# System Unbalance Examples

## Issue

- The PSE contribution to system unbalance calculated using the values and methods from Draft 2.1 33B-4 is not in conformance with Icon-2p-unb from Table 33-19
- This presentation simply shows that the system is inoperable as defined
- The 33B-4 method for testing the PSE contribution to unbalance is well thought out
- The model shown in Figure 33B-1 and 33B-4 needs a small adjustment for the calculation to work

Figure 33B-1—PSE PI unbalance specification and E2EP2PRunb

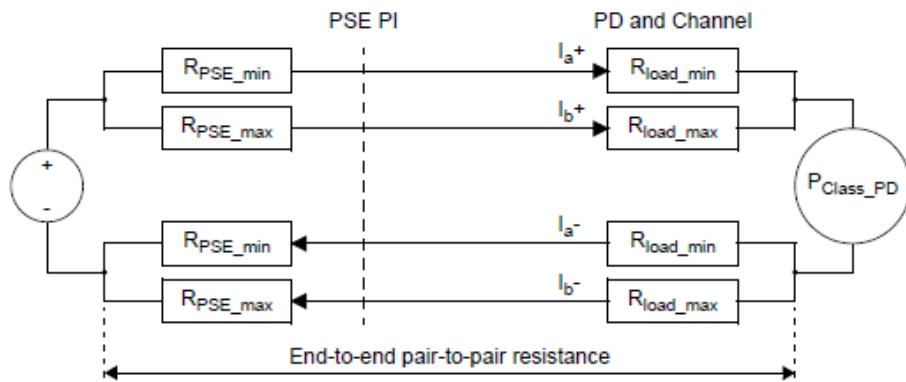
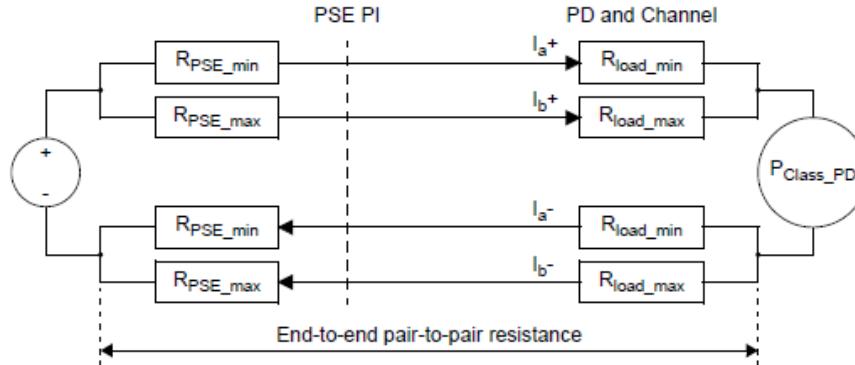
$$\text{Ia} = \mathbf{692.5mA} \quad <- \text{Violates } Icon-2p-unb \text{ (682mA)}$$

- Rload\_min and Rload\_max are the lumped sum of the PD and Channel Effective Resistances
- This causes an error in the calculation of Pclass\_pd
- I suggest we use a slightly more complicated model so that it is clear where the power calculation should be made.

- The PSE contribution to system unbalance calculated using the values and methods from Draft 2.1 33B-4 is not in conformance with Icon-2p-unb from Table 33-19
- The system model in figure 33B-1 should define Pclass\_PD at the PD PI
- Breaking the Rload resistances into Rpd and Rchan resistances and calculating Pclass\_PD at the PD PI brings the unbalance calculations back into conformance

## Replace Figure 33B-1

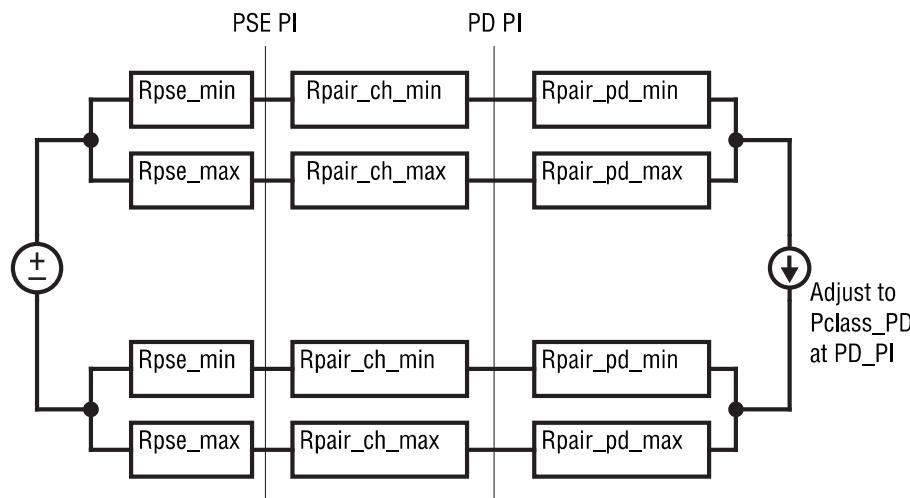
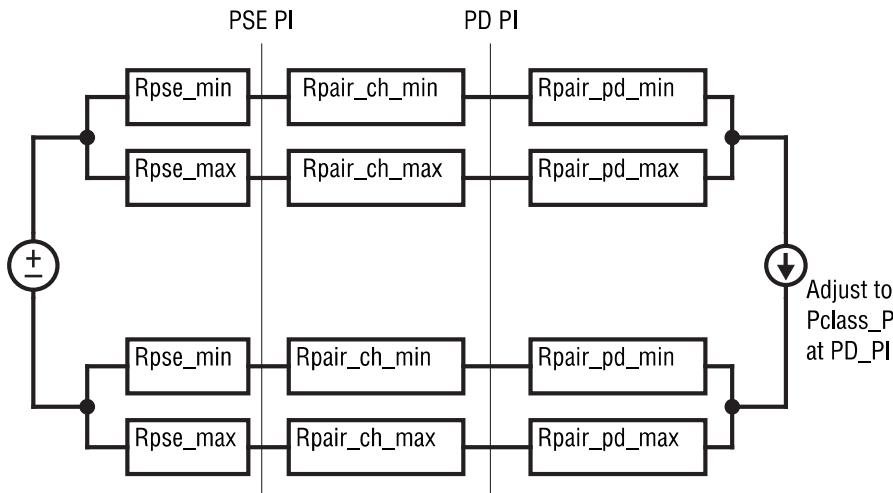
- Update Table 33B-1 so that Rload\_max and Rload\_min are broken into Channel and PD Components

$$Ra = Rpse_{min} + Rchan_{min} + Rpd_{min} = 0.723\Omega$$

$$Rb = Rpse_{max} + Rchan_{max} + Rpd_{max} = 1.450\Omega$$

$$\mathbf{Ia = 682mA <- This is in spec now (682mA)}$$
